WALKER
APARTMENTS

B_AD PROJECT
2506
FILE: WALKER_ST_SD_CF.RVT
DATE: 08/11/2025
DRAWN BY: DK
CHECKED BY: MRB

GENERAL INFO

PROJECT DESCRIPTION:	NEW CONSTRUCTION 15 TOWNHOUSES
PROJECT ADDRESS:	19 WALKER RD, EDGEWOOD, NM 87015
ZONING:	C-2 COMMERCIAL BUSINESS ZONE
PROPERTY LEGAL DESCRIPTION:	TRACT 2, AS SHOWN ON PLATE ENTITLED LAND DIVISION PLATE OF LANDS OF MARY JANE ROSE BEING A PORTION OF N1/2 NE 1/4 SE 1/4 OF SECTION 28, T10N, R7E, N.M.P.M., FILED IN THE OFFICE OF THE COUNTY CLERK, SANTA FE COUNTY, NEW MEXICO, ON OCTOBER 28, 1980, IN PLAT BOOK 86, PAGE 032, AS DOCUMENT NO. 467,301.

A3 SECOND FLOOR PLAN BUILDING D
SCALE: 3/16" = 1'-0"

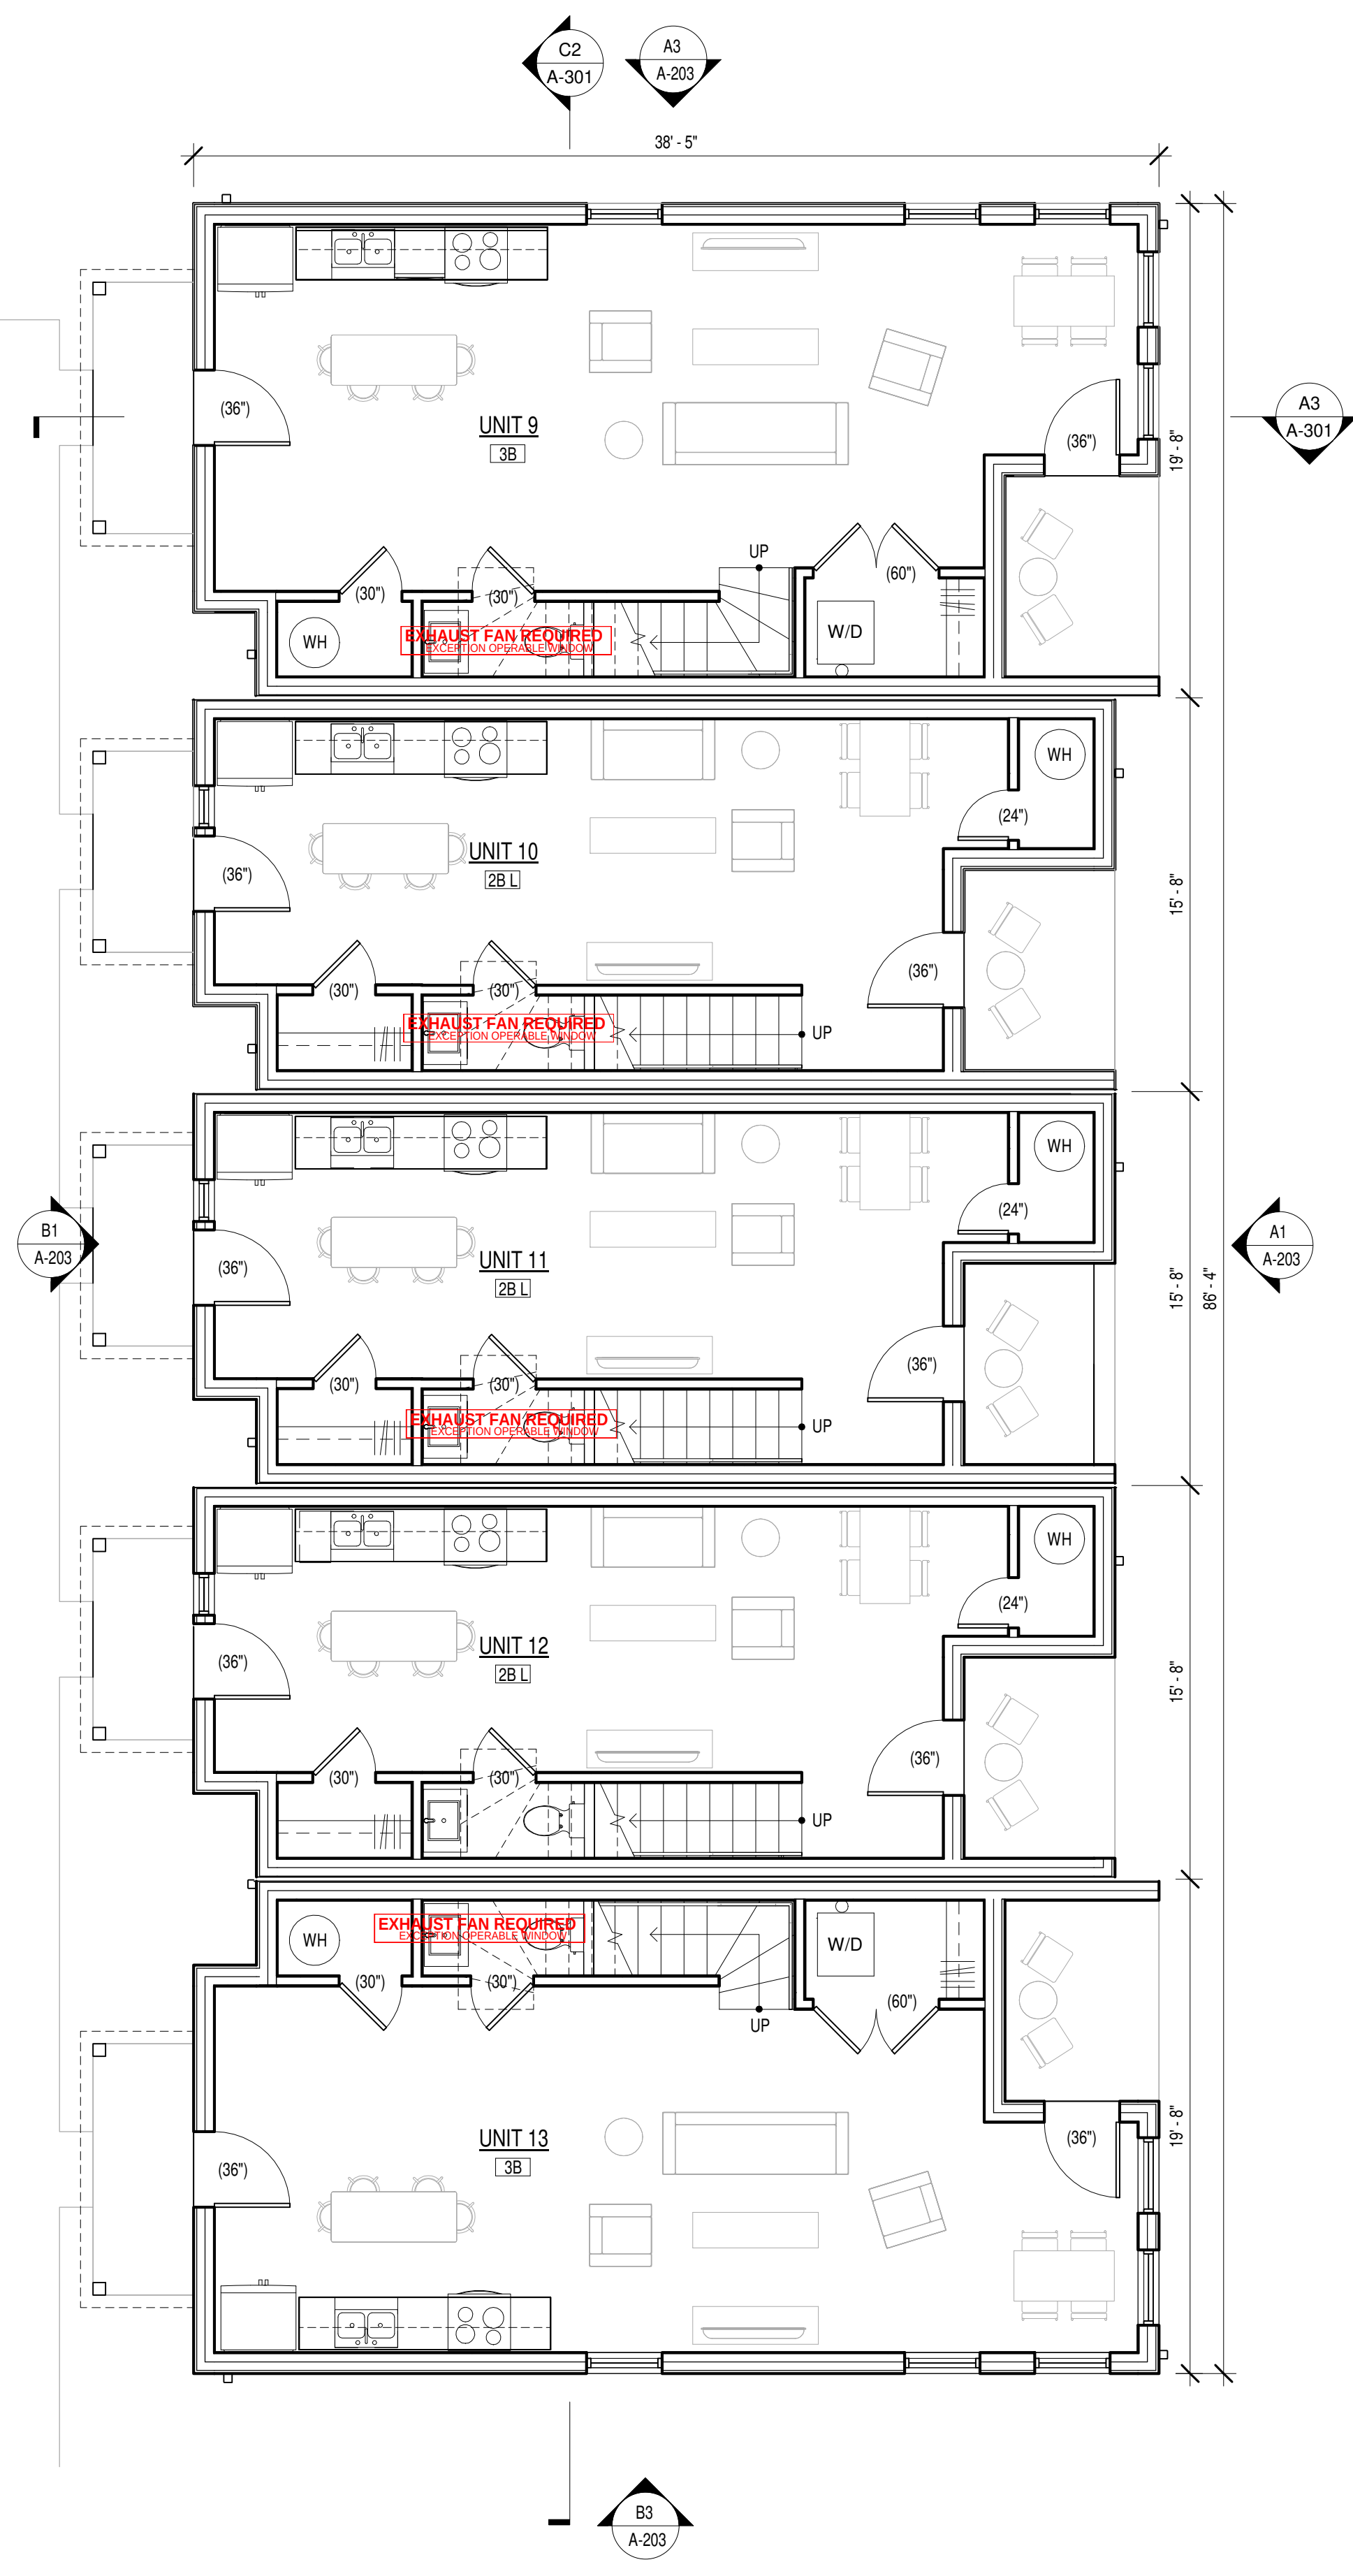
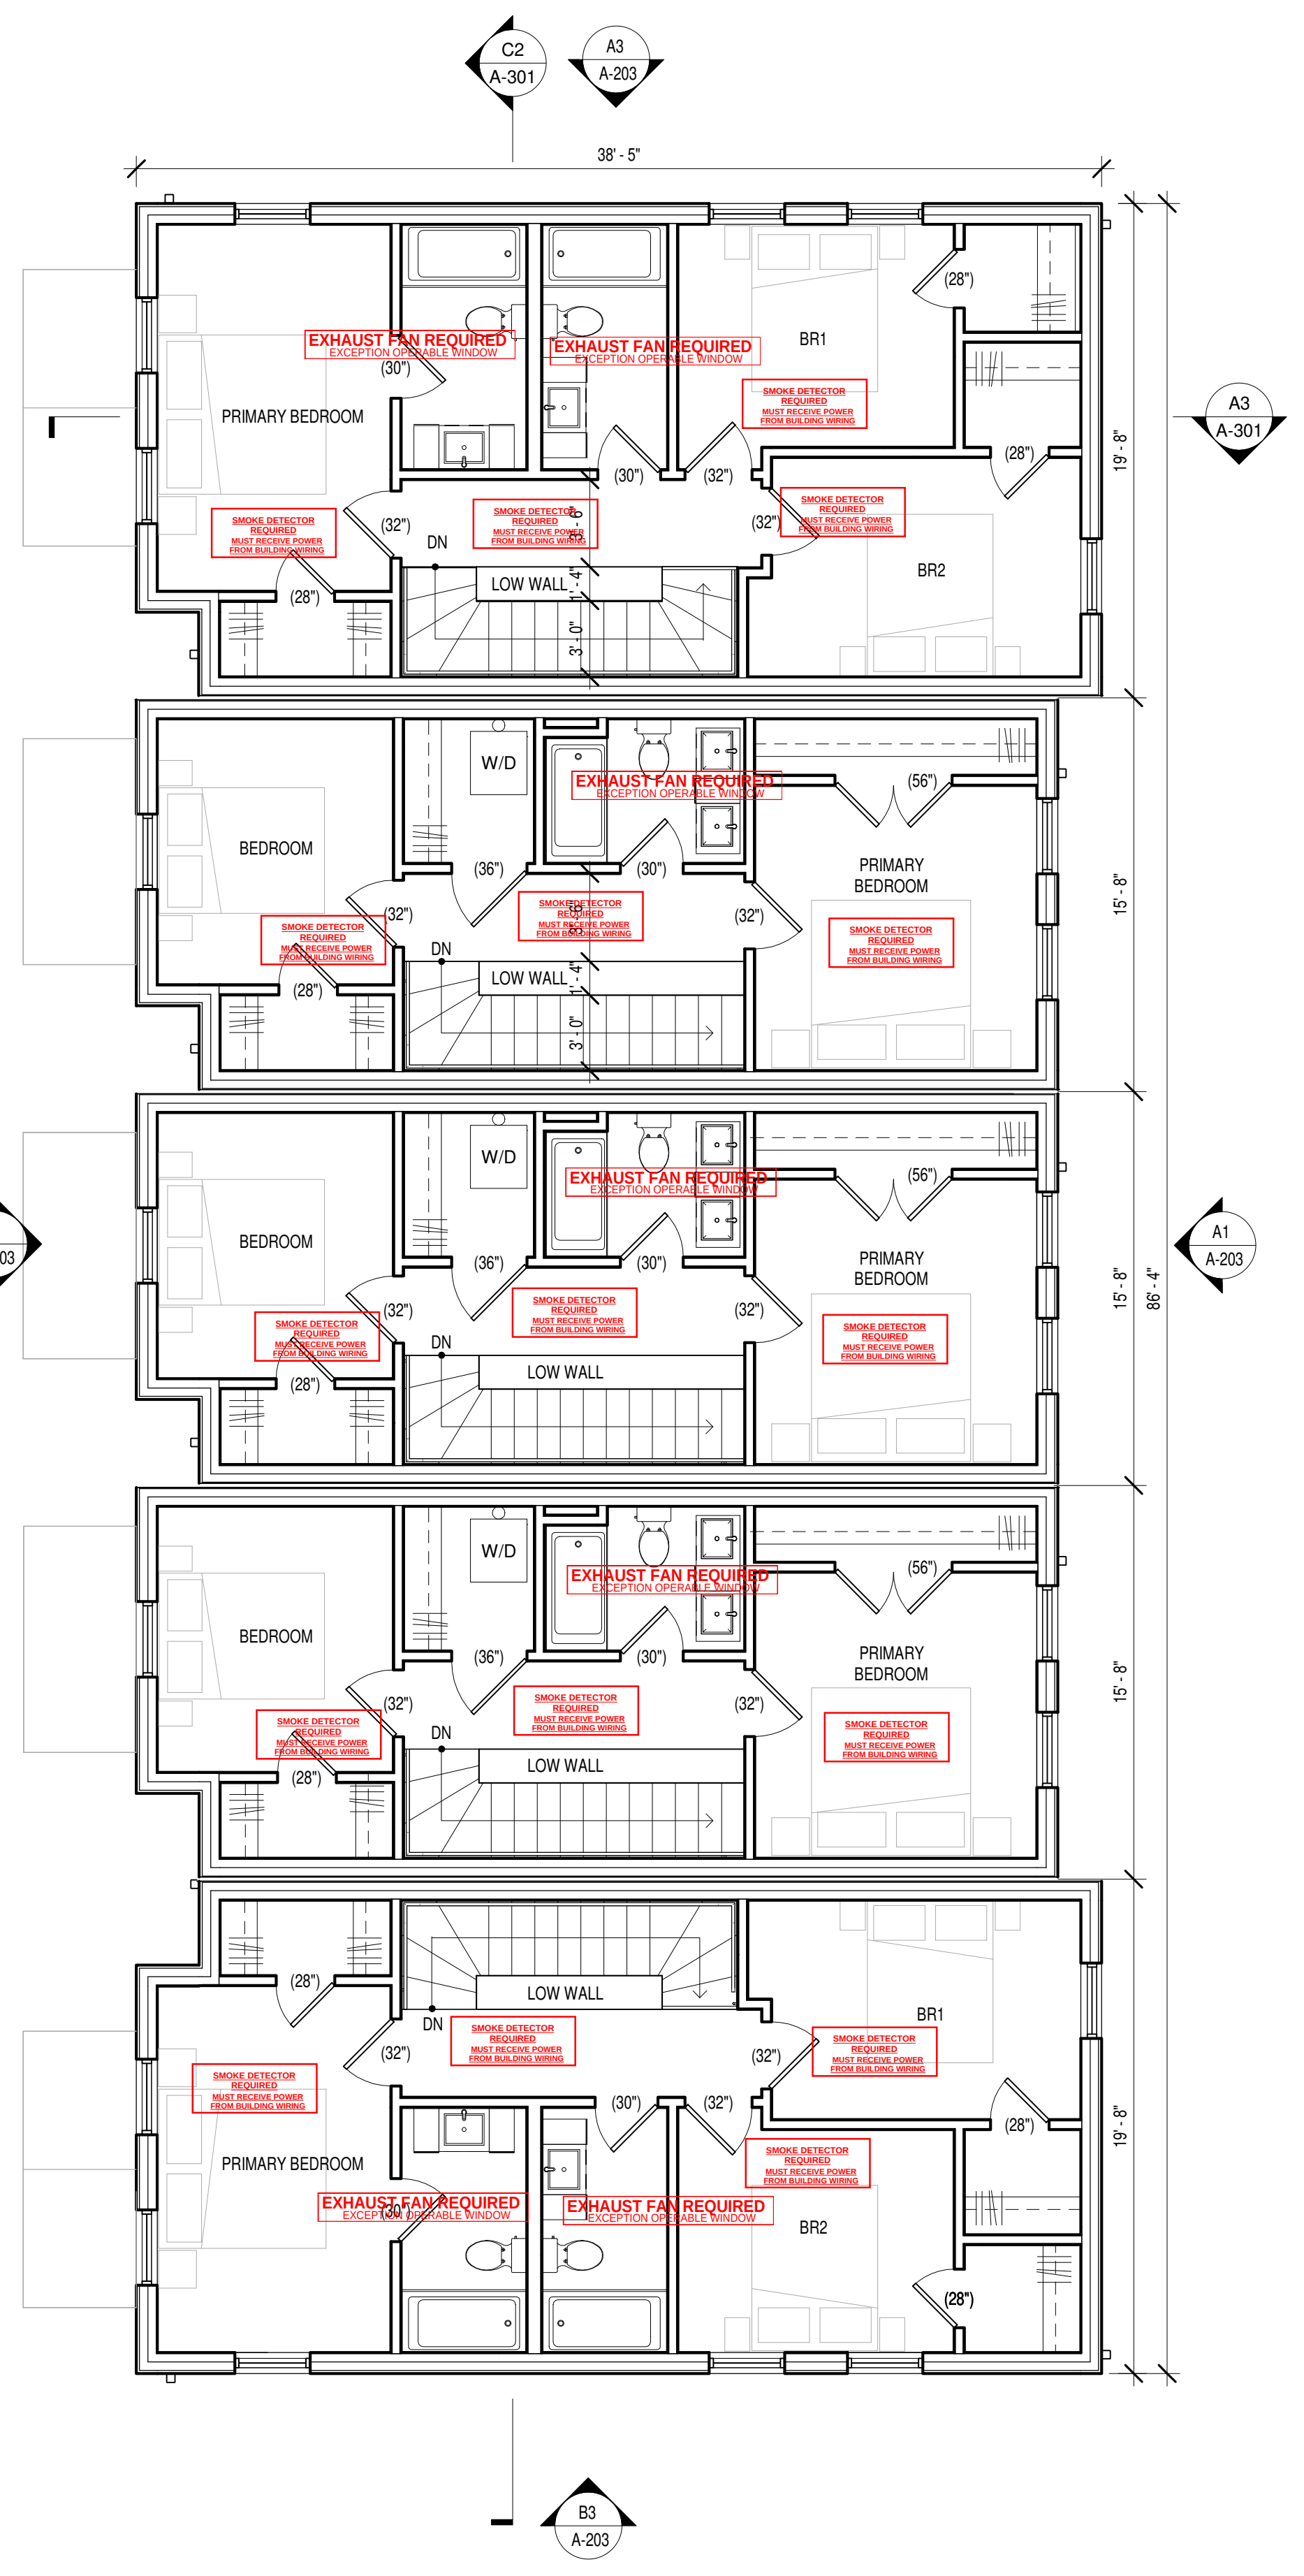
IRC
R308
SECTIONS
OF THE INTERNATIONAL RESIDENTIAL
CODE MUST BE COMPLIED WITH
(N.M. RESIDENTIAL BUILDING CODE)

Glazing

IRC
R609
SECTIONS
OF THE INTERNATIONAL RESIDENTIAL
CODE MUST BE COMPLIED WITH
(N.M. RESIDENTIAL BUILDING CODE)

Exterior Doors & Windows
